Bryant Planning Commission Meeting

Date: November 14, 2024 - **Time:** 6:00 PM

7. **Hillcrest Addition Subdivision - 3927 Springhill Road** - Preliminary Plat

Project No.: 24-018
Date: SEPTEMBER 20, 2024
File: 03_Hillcrest Culvert
Scale: 1" = 50'
Drawn By: B. Judd
Sheet: 3 of 10

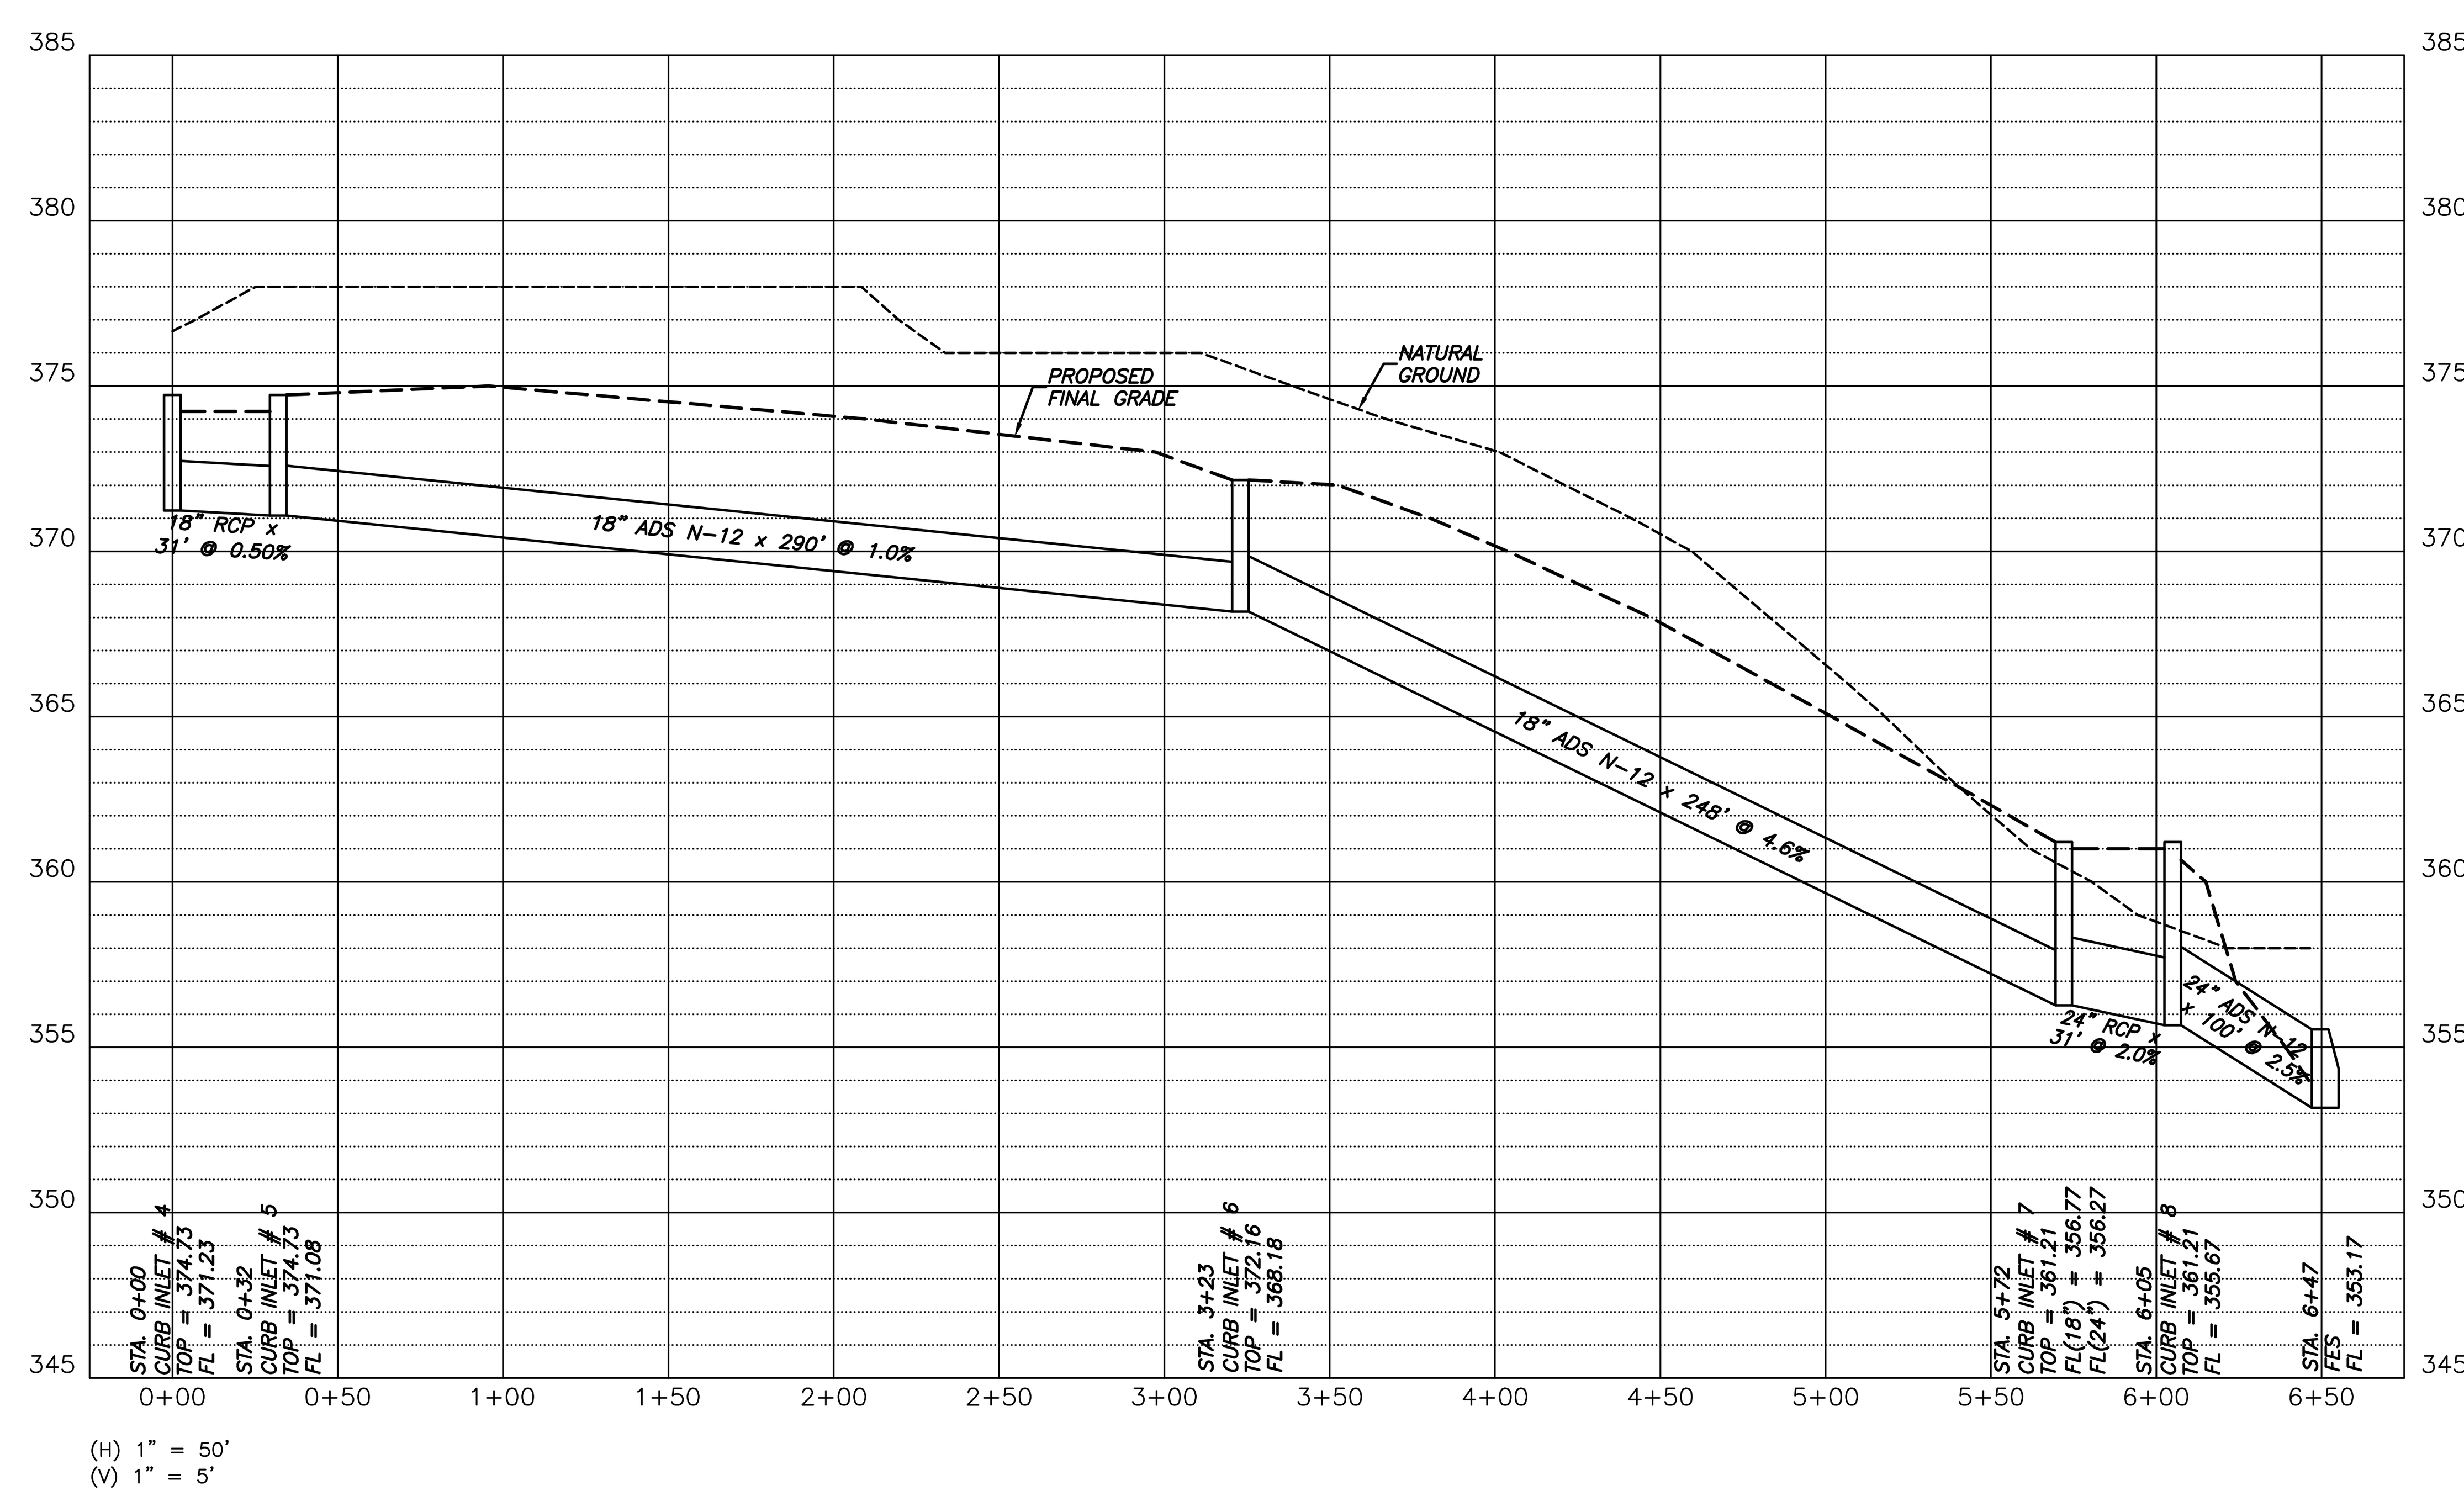
1. Sheet 3 of 10 shows the existing18" culvert stopping just behind the curb of the half-street improvements. Since the existing ditch will be graded over, it appears that this pipe should be extended to the north and pick up flow from the north. ***We will need to consult the owners as to when the half street improvements will be constructed. If the City and the Owner agree to an in leu of cost clause, the pipe will need to end in the vicinity of where it is shown on the existing plans. We are willing to discuss this with staff.***

2. Sheet 3 of 10, show the existing ditch & culvert to the south of JB#3 along Springhill Road. Show details on how the outlet looks and how the flow will be handled to the south. ***We will be matching the existing half street road improvements from our planned intersection, to the South. This has been added to this sheet.***

Date: JULY 9, 2024
Scale: 1" = 20'
Drawn By: B. Judd
Project No. 24-018
File: 05_Hillcrest Pond
Sheet: 5 of 10

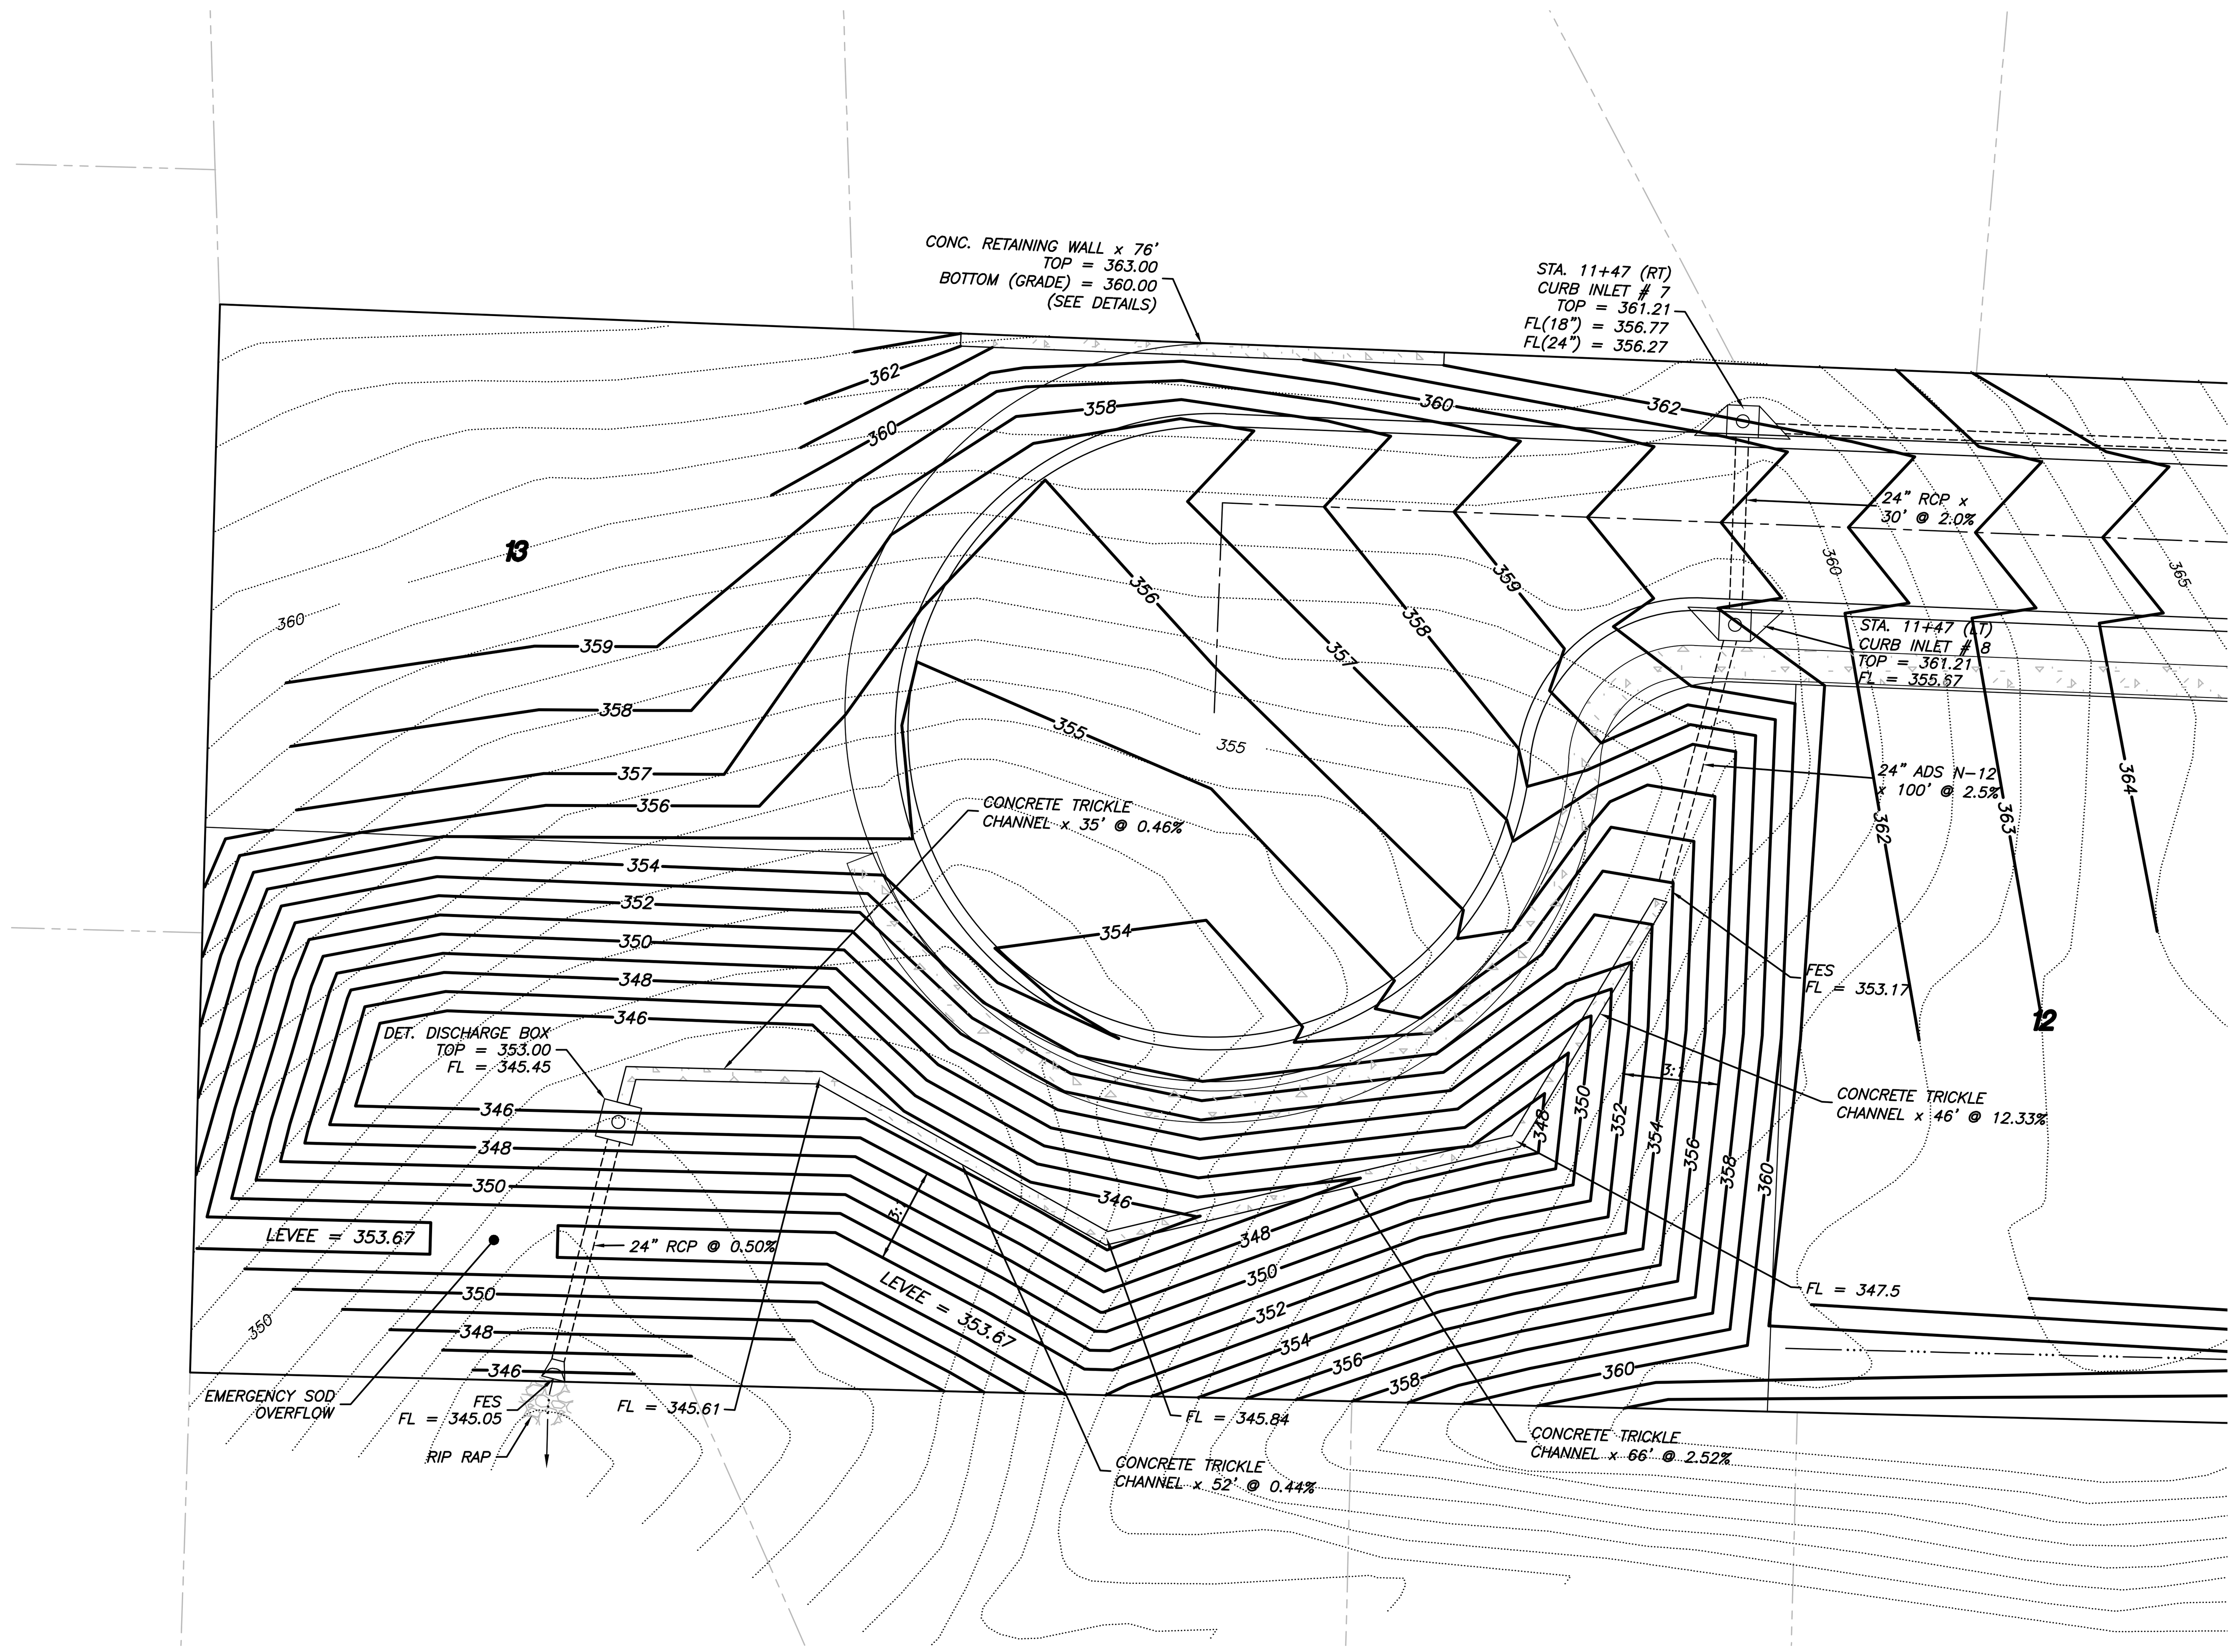
3. Sheet 5 of 10, show inlet numbers. ***Added as requested.***
4. Sheet 5 of 10, Is the top 4" slot all the way around the box beneath the top? ***Yes. I have added additional information on this detail to better represent this item.***
